ADDENDUM NO. 3
10/21/2019

NEW PORTABLE CLASSROOM BUILDING
Camarillo Academy of Progressive Education

PBK Project No.: 191726

ADDENDUM NO.3 - AD-3.0

ADDENDUM NO.3 - AD-3.4

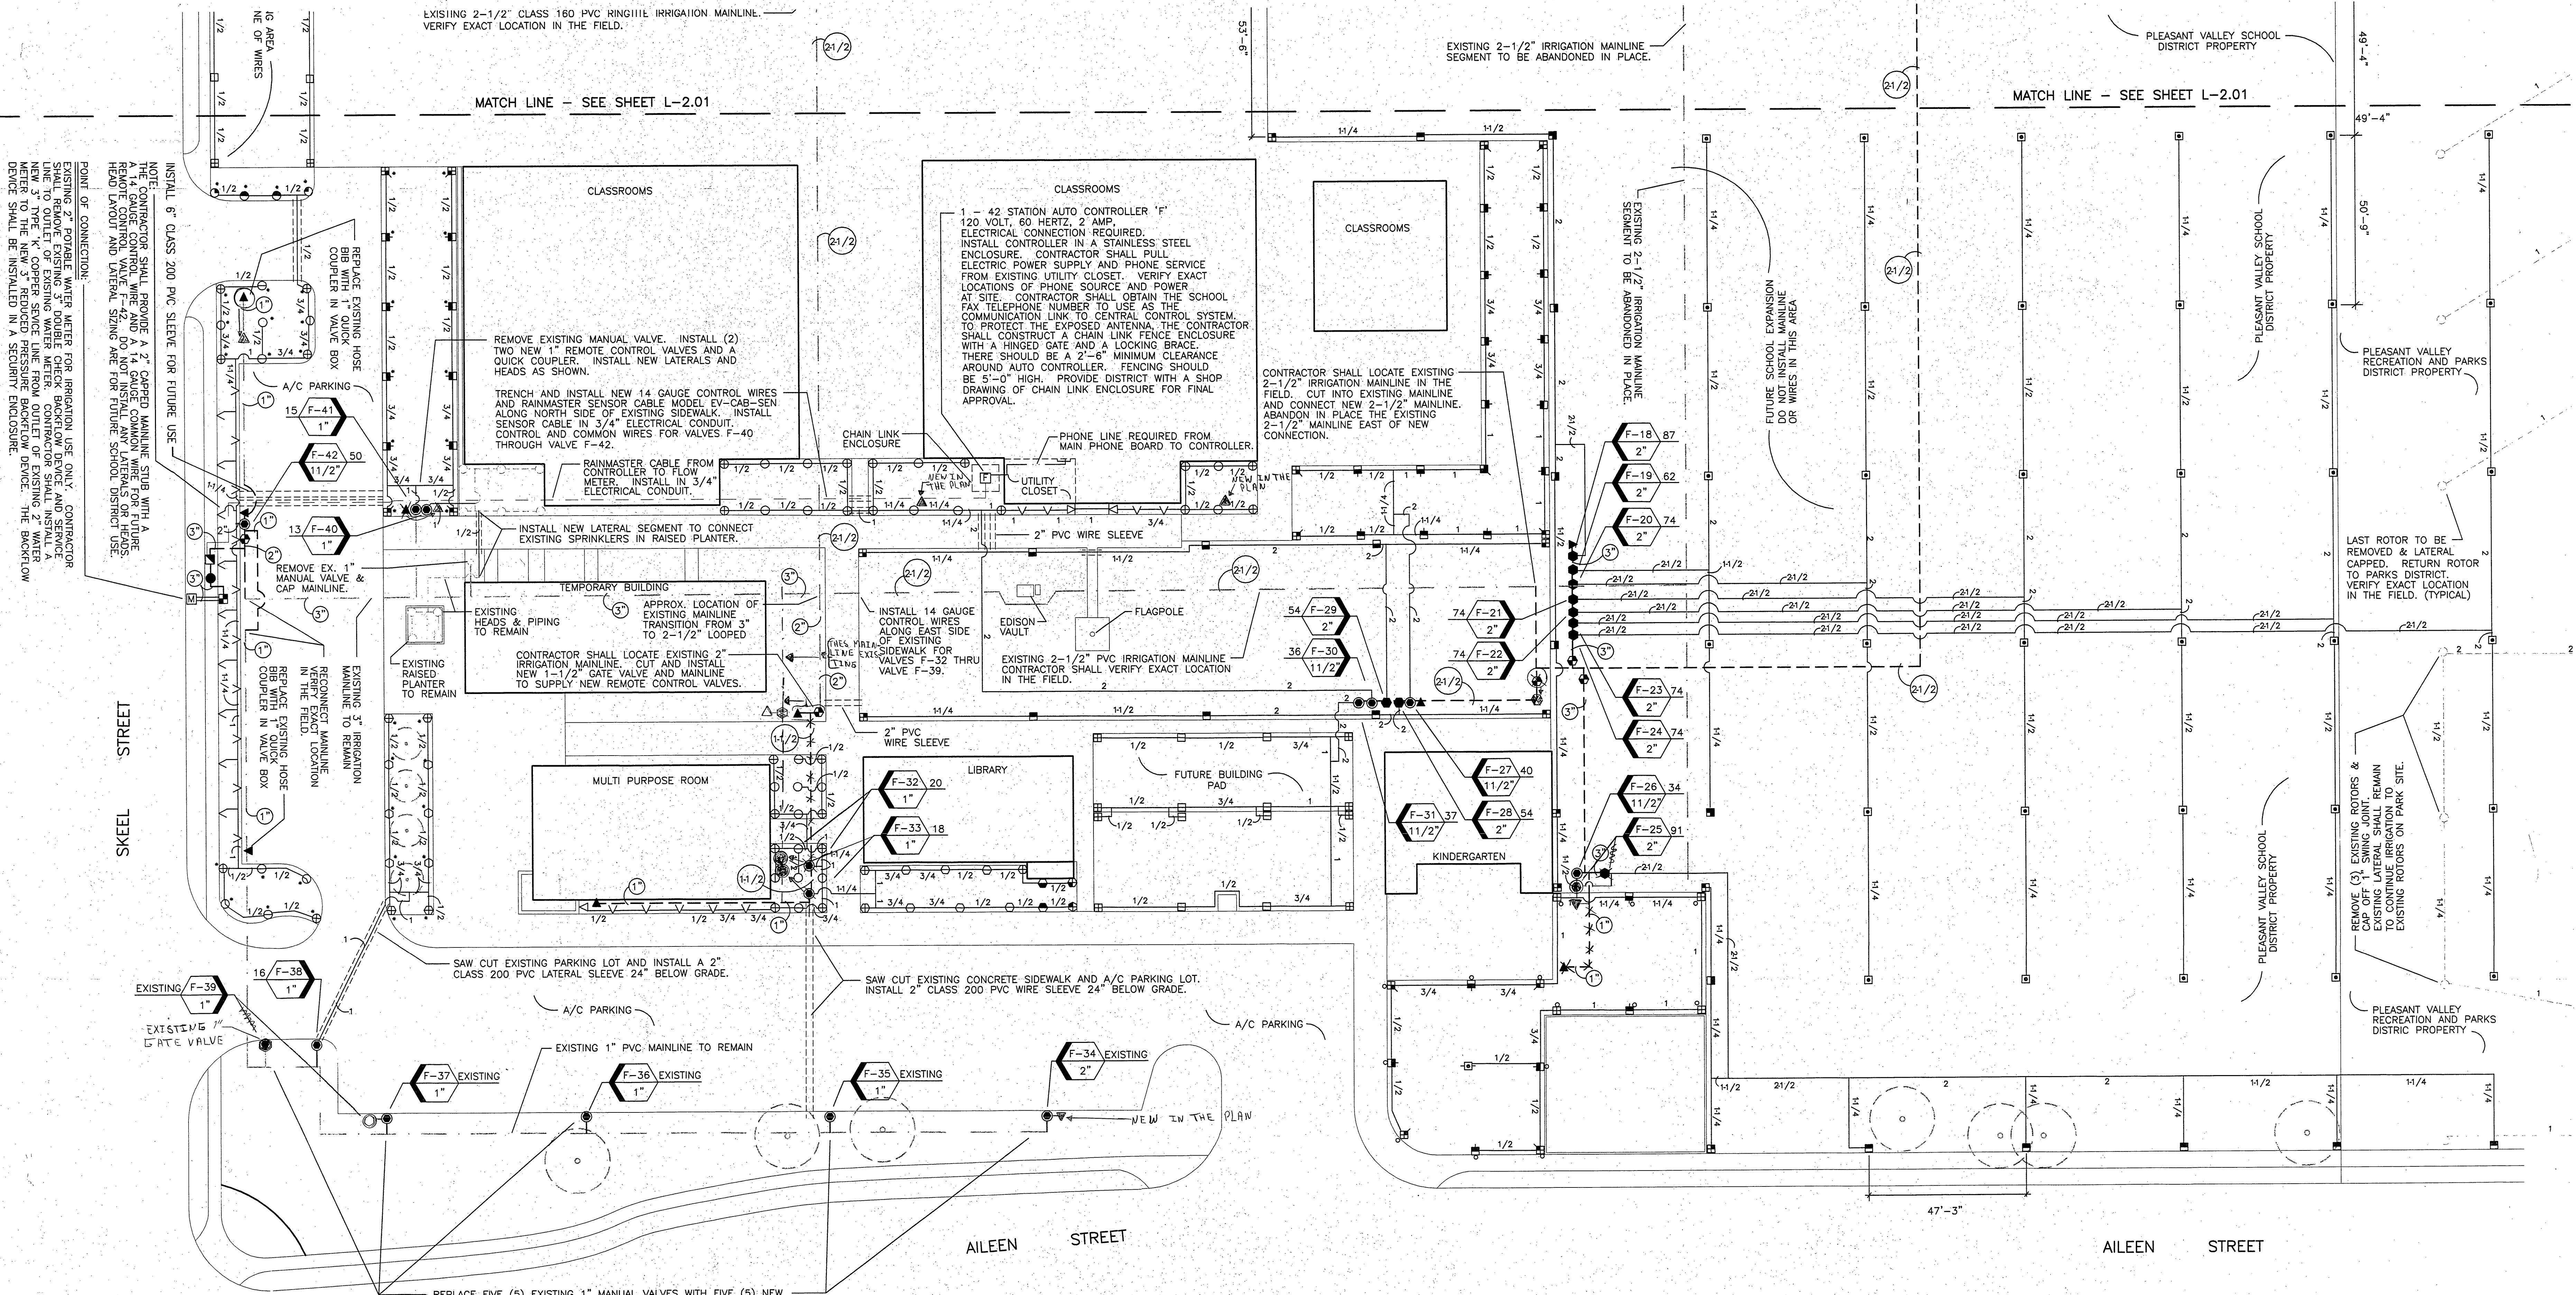
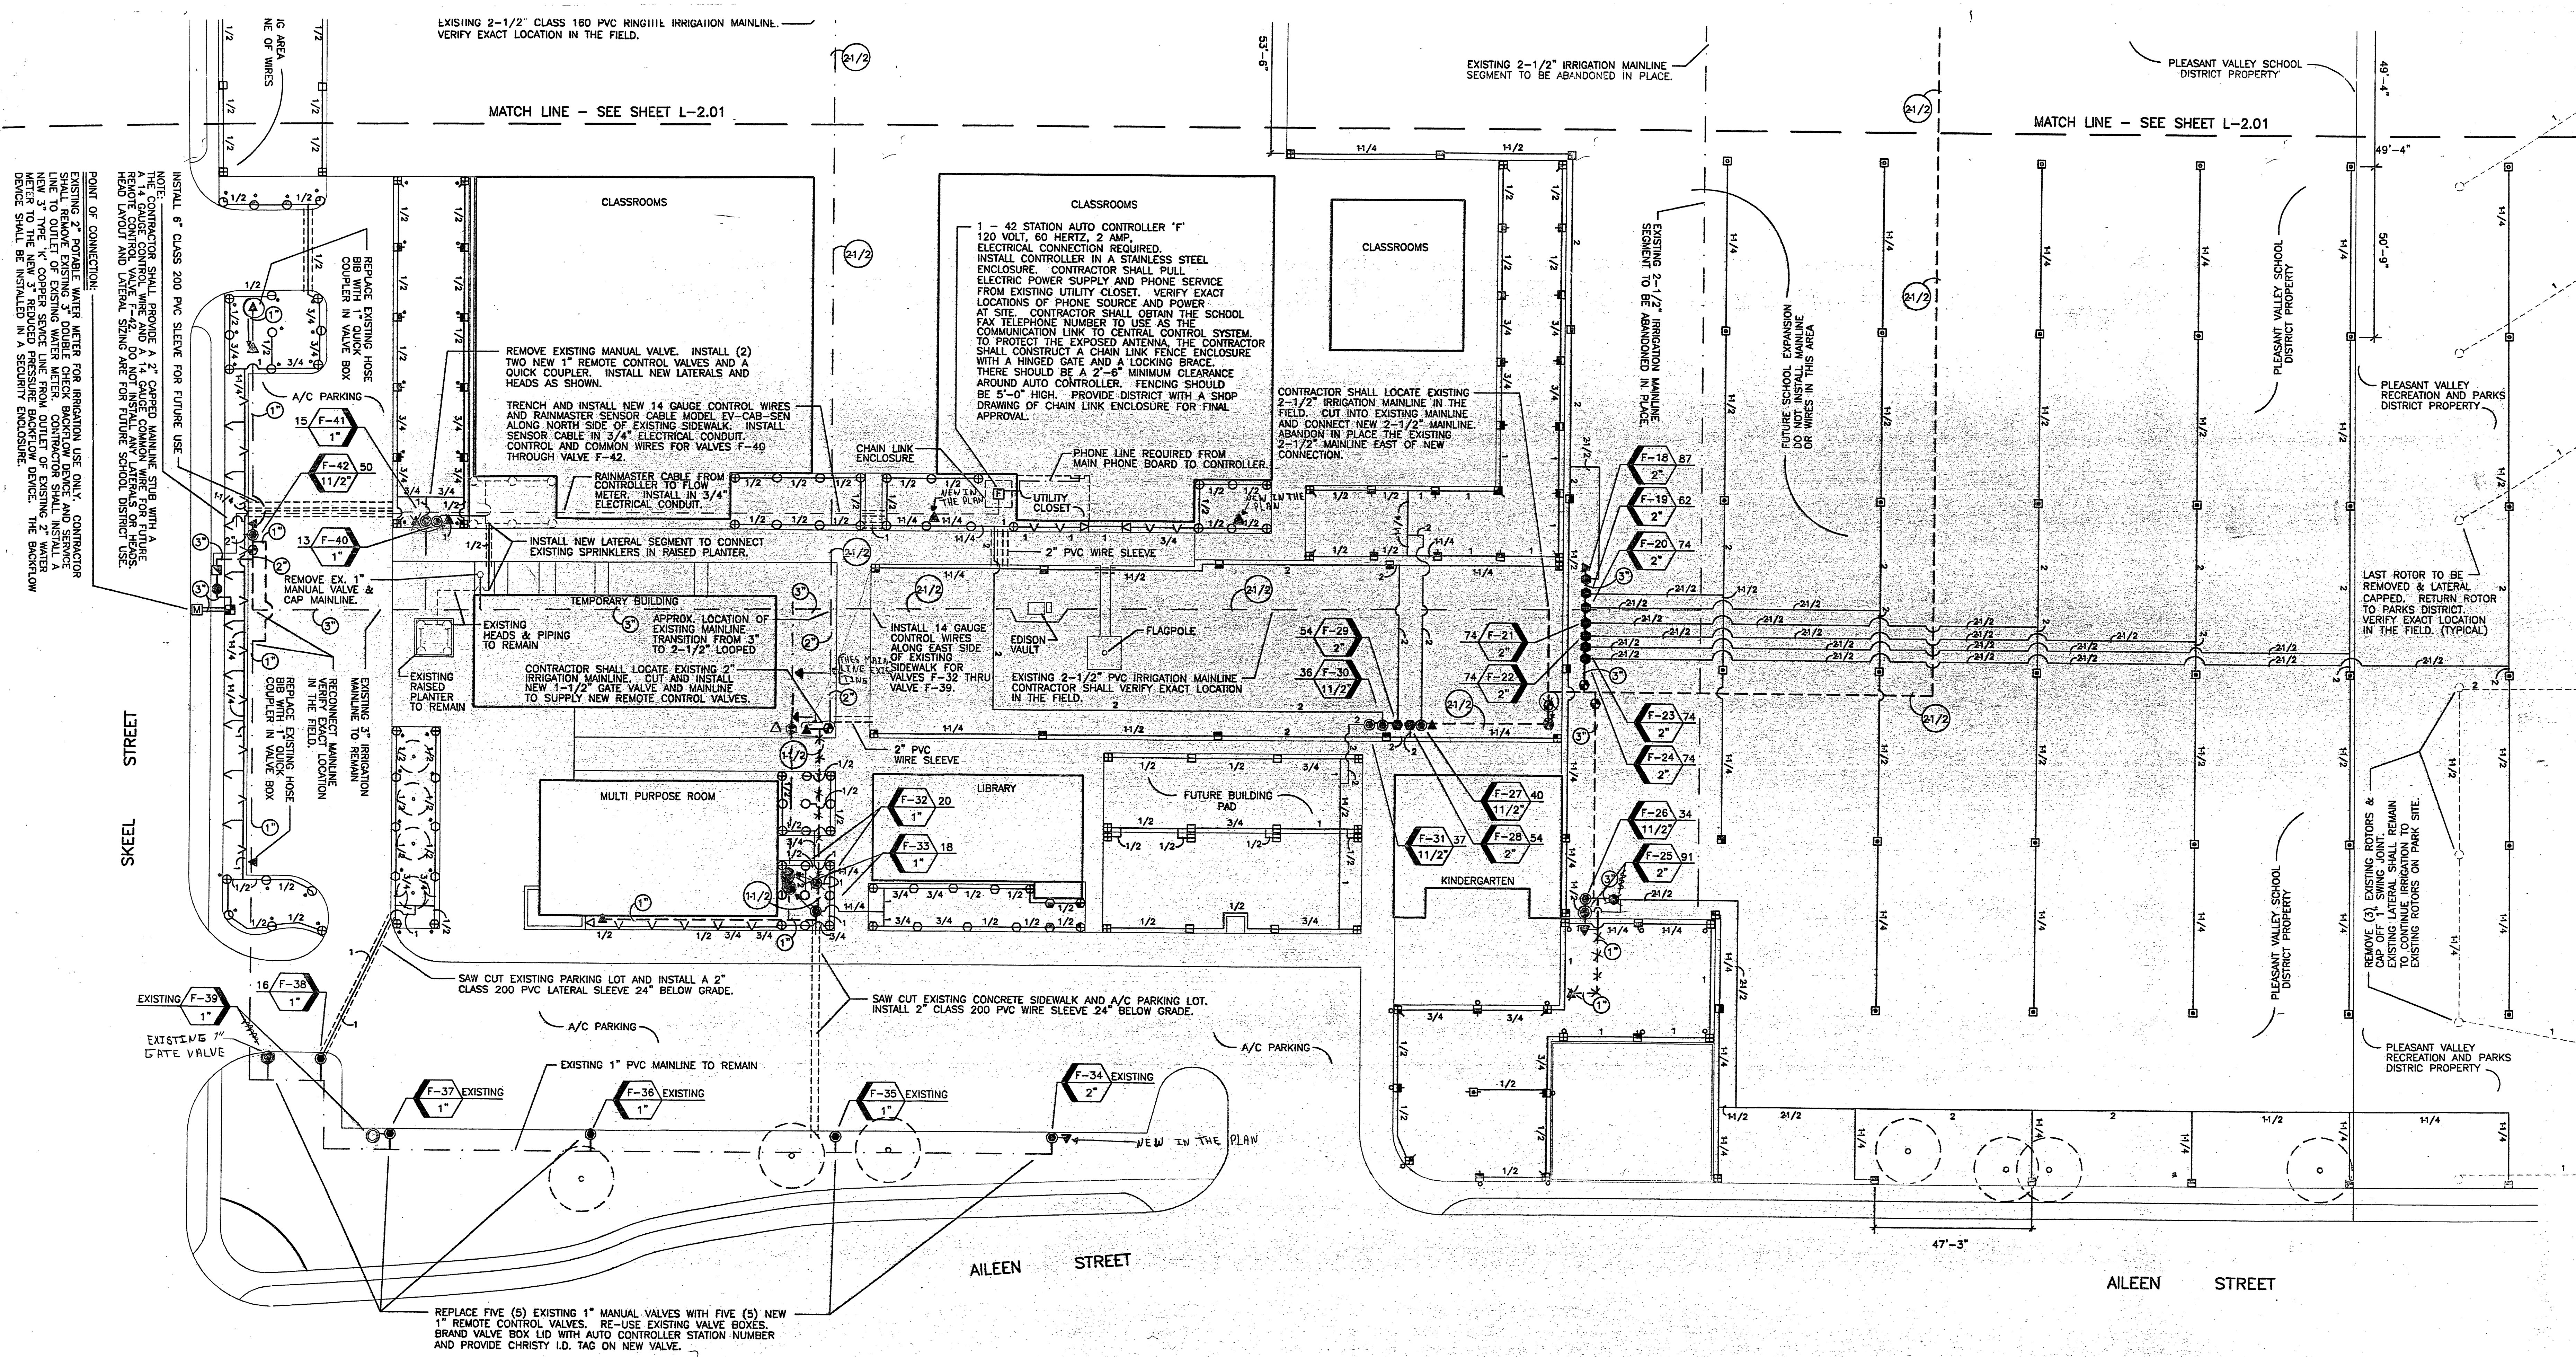
4. AD-3.4 Landscape and Irrigation Record Drawings
A) See attached for landscape and irrigation record drawings.

5. During the site walk it was noticed allot of irrigation valves that will impact the project. Does the District know the lines location? Will the District cap off the lines under the new project?

RESPONSE: Contractor is responsible to cut and cap existing sprinkler lines that are affected by new construction. See attached drawings for approximate irrigation system layout and coordinate with Owner prior to irrigation system modification.
